TVA-WBN-TS-00-11

**WATTS BAR NUCLEAR PLANT (WBN) UNIT 1 - TECHNICAL SPECIFICATION  
(TS) CHANGE NO. 00-11 - "INCREASE IN DEGRADED VOLTAGE TIME DELAY"**

#### PROPOSED TECHNICAL SPECIFICATION (TS) CHANGE TS-00-11 DESCRIPTION AND EVALUATION OF THE PROPOSED CHANGE

FIGURE 1

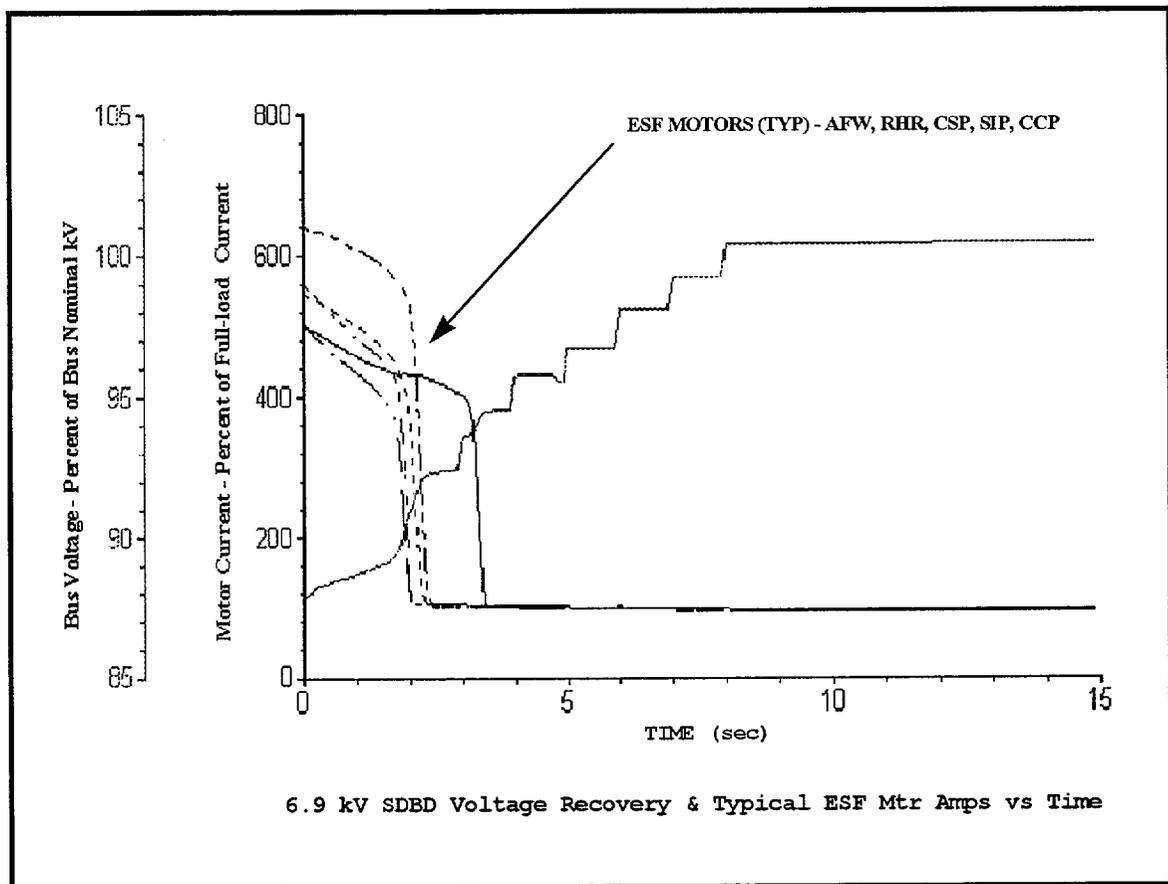
Specifically, the analysis demonstrates that required safety related equipment in operation at the time a degraded voltage condition occurred would continue to operate throughout the 10 second delay. If the degraded voltage condition cleared during this time period, the voltage would return to nominal levels and be available for equipment required to perform safety functions. Calculations demonstrate the following:

- ESF motors required to mitigate an accident will have sufficient voltage available at the terminals to ensure proper starting and operation, when supplied by offsite power. This includes achieving rated speed within five seconds after an SI initiation signal which simultaneously starts all ESF motors. Figure 1 below illustrates the composite response of the full load amperage for key ESF pump motors (auxiliary feedwater, residual heat removal, containment spray, safety injection, and centrifugal charging) plotted with a typical worst case 6.9 kV Shutdown Board voltage recovery profile based on plant calculations.
